In The Matter of the Resource Management Act 1991 ("the Act") And
In The Matter Rolleston Plan Change 81/82

OFFICER COMMENTS OF ANDREW BOYD

Figure 1. Recovery Park activities in relation to Plan Change 82 land.

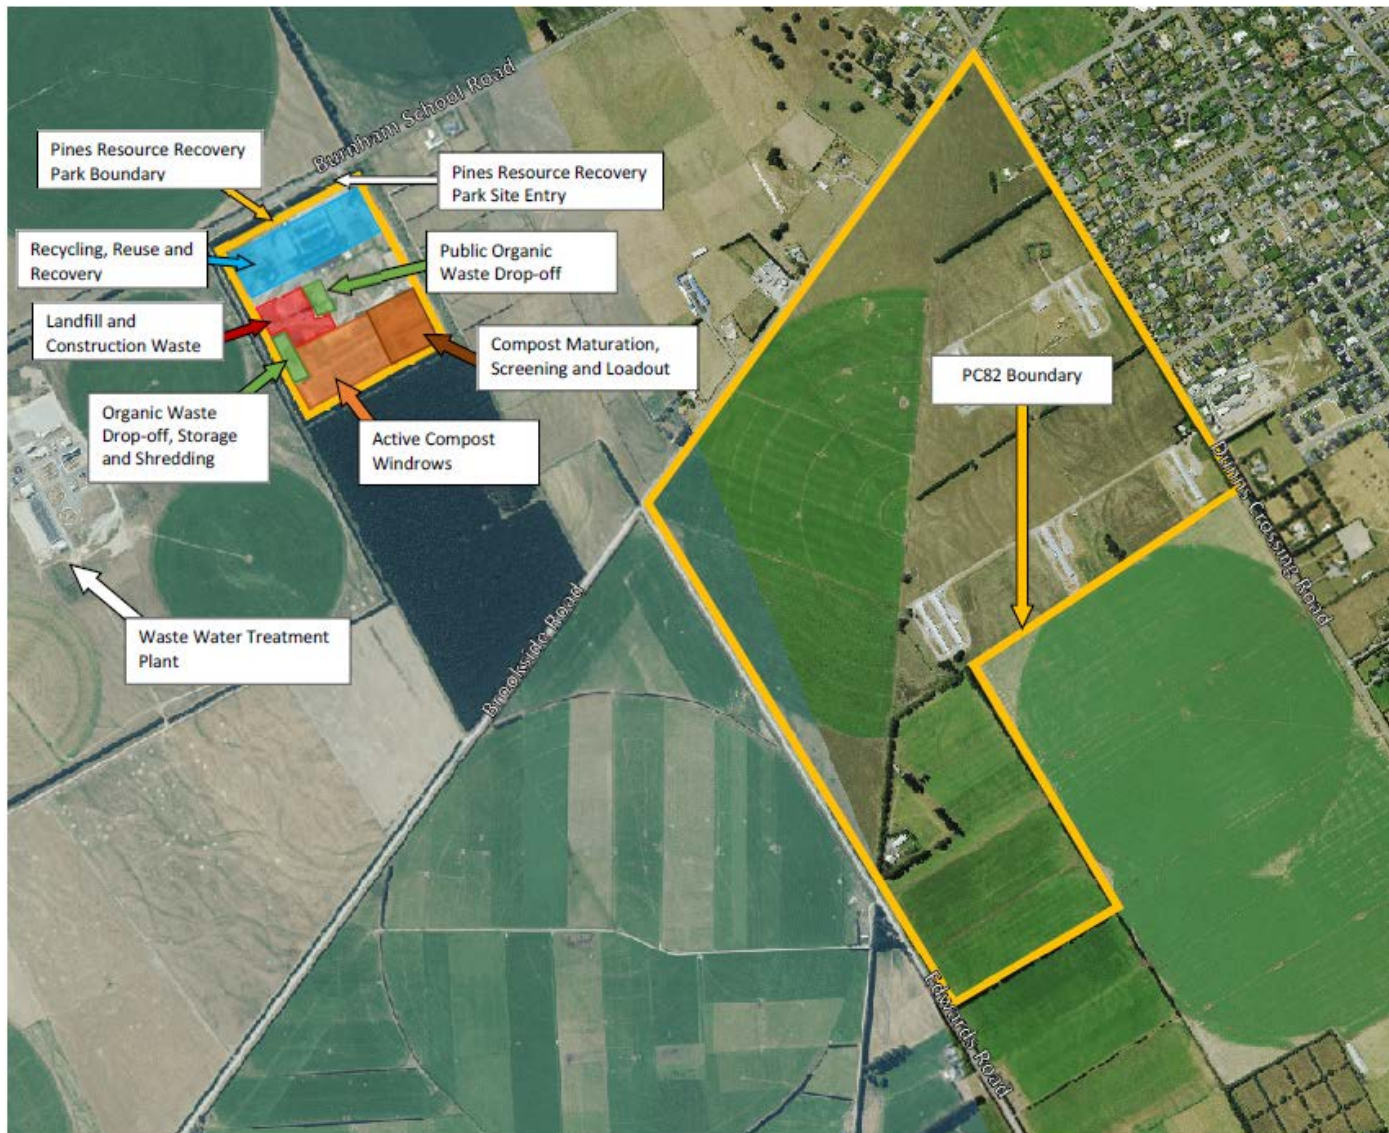
20. In the PC82 application, the proposed setback distances are taken from the edge of the active composting area. The consented composting area extends to the edge of the maturation area. Given that screening, and loading out of mature compost occurs from the maturation area, there is potential for odour and dust effects to result in reverse sensitivity issues on composting operations, from residences within the PC82 area. I would propose that a more

appropriate point at which to take the setback buffer, would be from the edge of the maturation area, as marked in figure 1. Albeit in my view a larger buffer than what is currently proposed. One that is more in line with Victoria EPA guidelines would be more appropriate to protect essential Council infrastructure.

Figure 2. Organic waste tonnage projection to end of consent in 2044

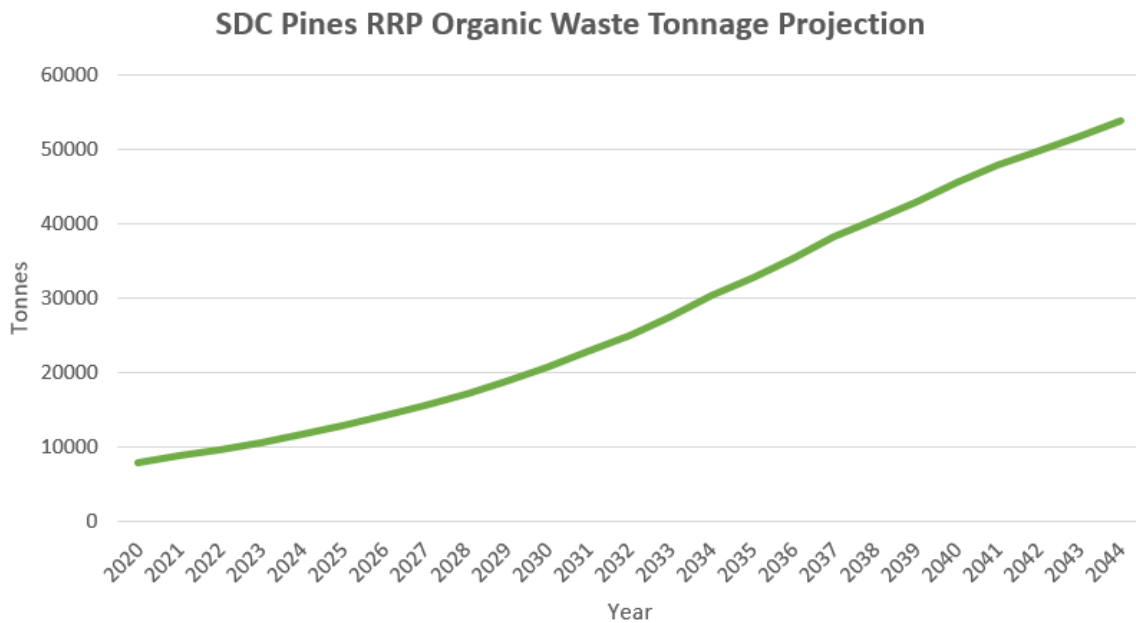
13. Projections for general waste and organic waste through to 2044 have been made, and these are reflected in the limits within the consent condition 2a (provided above in paragraph 12).

30. At the time of lodging PC73, organics tonnes were at 8,000 tonne per annum. Condition 2a of CRC211594 provides for 53,000 tonne per annum. Council expects organic tonnages to increase to 53,000 tonne per annum over the duration of the consent, i.e., through to December 2044.

Figure 3. Wind rose for Burnham (closest anemometer), 1 June 2017 to 31 May 2018, all hours (wind direction is blowing from).

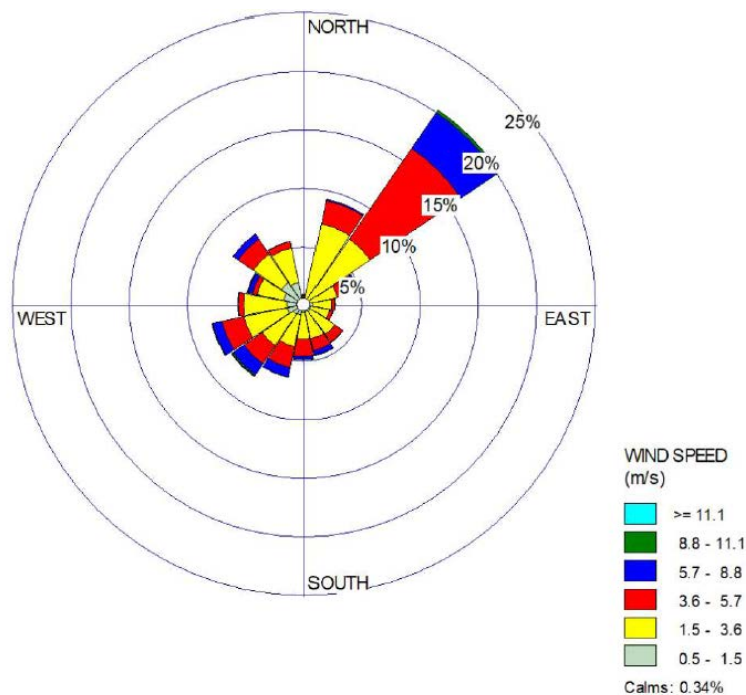
21. The wind blows from the North West, towards the PC82 block, approximately 18% of the time.

22. Two concerns are present relating to wind speed.

- a) Low speed winds from the north west have the potential to blow odour across to the proposed dwellings within PC82.
- b) High and sometimes gale wind speeds during Canterbury's renowned strong nor wests have the potential to blow dust from compost stockpiles within the maturation area, across to dwellings within PC82.
